UNITED STATES DEPARTMENT OF COMMERCE United States Patent and Trademark Office Address: COMMISSIONER FOR PATENTS P.O. Box 1450 Alexandria, Virginia 22313-1450 www.uspto.gov

APPLICATION NO.	FILING DATE	FIRST NAMED INVENTOR	ATTORNEY DOCKET NO.	CONFIRMATION NO.
10/617,791	07/14/2003	Shinjiro Hara	BD-0302T	4079
7590 02/12/2008 TAKEUCHI & KUBOTERA, LLP			EXAMINER	
200 DAINGER	FIELD RD. SUITE 20		SEVERSON, JEREMY R	
ALEXANDRIA,,, VA 22314			ART UNIT	PAPER NUMBER
			3653	
			MAIL DATE	DELIVERY MODE
			02/12/2008	PAPER

DETAILED ACTION

Applicant's representative, Kazunao Kubotera, contacted the Examiner to notify him that the Final Rejection mailed 27 November 2007 was mistakenly sent to the wrong address. In response, this Office action is being mailed to the correct address, and the statutory period for reply is based on the mailing of this action.

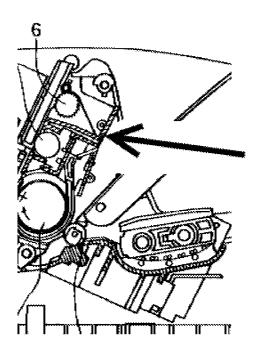
Claims 1, 3, 4, 6, 8, 11, 12, 19, 20, 23, 24 and 27-30 are rejected under 35 U.S.C. 102(b) as being anticipated by Nishiberi (US 5,984,300).

Re claims 1, 11, 19 and 29, Nishiberi discloses a medium tray attachable to an image recording apparatus for feeding a record medium one by one and recording an image on said record medium, said medium tray comprising: a depository in which a plurality of said record media is loaded such that front and rear portions of said record media have different angles with respect to a feeding direction of said record media when said record media are in said depository, said depository including a medium support (downstream portion of 9) for placing the front portions of the record media and a rear guide (upstream portion of 9) extending upwardly from a rear end of the medium support for guiding the rear portions of the record media upwardly, said medium support protruding outside of the image recording apparatus from a side of the image recording apparatus to be exposed; and a folding member 2 provided at a rear portion of said depository for folding the record media so that the rear portions of the record media are folded toward the image recording apparatus with upper surfaces of the record media inward, said folding member being disposed at an upper portion of the rear guide, said folding member including a guide member for guiding the record media toward the image recording apparatus. The surface of 2 on which the record medium rests serves to guide the sheet.

Re claims 3 and 6, Nishiberi discloses everything claimed, including a restricting member arranged at said medium support or rear guide and restricting said record media put in said depository such that said record media are not spaced from said medium support or rear guide more than a predetermined distance and is transported along said medium support or rear guide when said record media are fed into said image recording apparatus. Arrow in fig. below points to restricting member.

Re claim 4, Nishiberi discloses the medium tray according to claim I, wherein said depository further comprises a curved section between said medium support and rear guide. Elements 9 and 2 are curved along their entire length.
